Re: PLANNING APPLICATION NO CE/13/01696/FPA

Conversion of former hospital and its extension to form 73 student studios, erection of student accommodation building to include 367 bedrooms, demolition of outbuildings and extensions, and cycle storage, parking and altered site access, by Peveril Securities.

I write in connection with the above planning application on behalf of Durham University Bicycle User Group (DBUG). We have examined the application and plans and know the area well. As DBUG have been referenced in the supporting documentation to the planning application (*Transport Statement and Travel Plan* at paragraph 2.3.10) we wish to comment on the development's cycle parking provision and location, and the infrastructure connections with the University and the City.

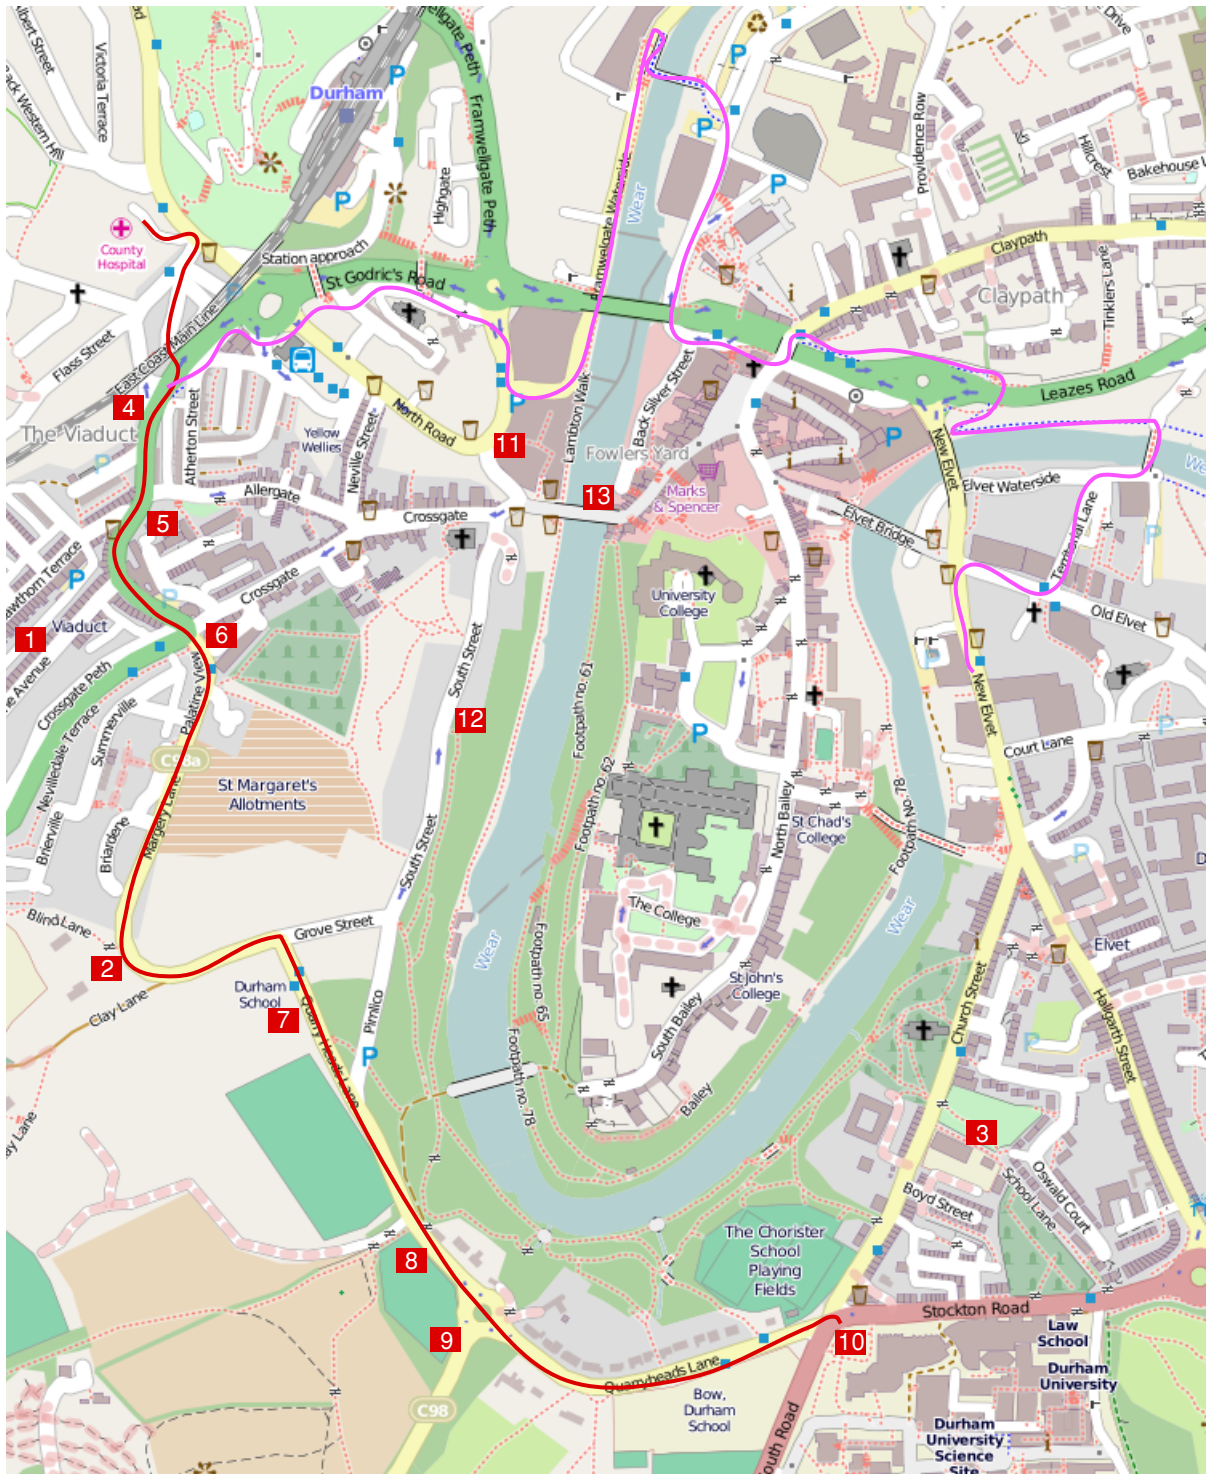
The main route used by cyclists and pedestrians from the development to the Mountjoy campus of the university will go along Sutton Street, the A690, Margery Lane & Quarryheads Lane. See the accompanying map to follow the notes: numbers in round brackets in the text refer to the red numbers on the map, and the route is marked in red.

The route is also used in part by students living in the Viaduct area (1) and by people living in the Neville's Cross area, emerging via Clay Lane (2). Neighbouring Blind Lane is a popular pedestrian route to St Margaret's Primary School. Other pedestrians and some cyclists use parts of the route to access St Oswald's Infant School on Church Street (3).

The route begins at the development. At the main site entrance with North Road you can either turn under the railway viaduct on to the main roundabout and then south-west on the A690, or continue via a residential road, Sutton Street. At (4) the NCN14 cycle route (on the pavement) crosses the main road via a badly signed pedestrian refuge. It is not clear to cyclists whether they are really allowed to do this.

The road continues uphill, pretty steeply. It is not a wide road so overtaking by motor vehicles is a hazard. At (5) an on-road advisory cycle lane commences, on the east side of the road only. This continues to the advanced stop box at the junction (6). The lane is useful because it allows cyclists to continue their slow progress up the hill when the traffic is queuing at the lights, but this is the only piece of dedicated cycle infrastructure on the journey.

After the junction, the route continues along Margery Lane. Margery Lane and Quarryheads Lane are used by a fair number of cars, especially taxis travelling from the station to the university & beyond. There are a number of issues facing cyclists and pedestrians along the stretch from (6) to (9).

The road is extremely busy with students walking to the university, but the conditions are sub-standard. The pavement is rarely wider than 130cm along the whole distance. At its narrowest point (7) it is only 80cm including the kerb (this is not the narrowest point of the carriageway either), and from there to (8) is mostly about 100cm wide.

Between (7) and (8) there are no drains in the gutter, so during heavy rain a stream up to three feet wide forms in the road. Pedestrians run the risk of being showered by passing cars, and as a cyclist you either have to ride very much further out than usual or accept that you will get home with your shoes soaked. During the autumn there is a lot of leaf fall as the surroundings have a lot of trees.

At (8) the minor road from the river bridge merges in. At last there is pavement again on the other side, and some pedestrians will cross here, particularly parents and children going to St Oswald's school. Crossing the road here is tricky as there is poor visibility in each direction, and there is no pedestrian refuge. The road curves and cars are obscured by a low wall. From

the roundabout (which is excessively big and therefore easy to drive round at speed) cars will approach without warning. In general, the absence of pavement on the east side of the road encourages drivers to exceed the 30mph speed limit, and a similar effect happens on the steep downhill approach to the roundabout from the road marked C98 (Potter's Bank). At the crossing of that road (9) there is an absurdly small pedestrian refuge.

Between (9) and (10) the width of the road is generous. If parking or the width of the grass verges could be reduced there would be ample width for a bi-directional segregated cycle route, in line with the Dutch CROW standards, as aspired to in the DCC Cycling Strategy. On such an important route this should be actively under consideration.

Cyclists have few other options for routes from the development to Mountjoy campus. While it is possible to cycle down North Road, it is not in theory permitted to continue right at the Milburngate junction (11) and South Street (12) is one way the wrong way. Framwellgate Bridge is closed to cyclists, being pedestrian only (plus delivery vehicles until 10am).

The route in purple on the preceding map shows how to reach the University's Elvet Riverside buildings using the official cycle infrastructure in the area.
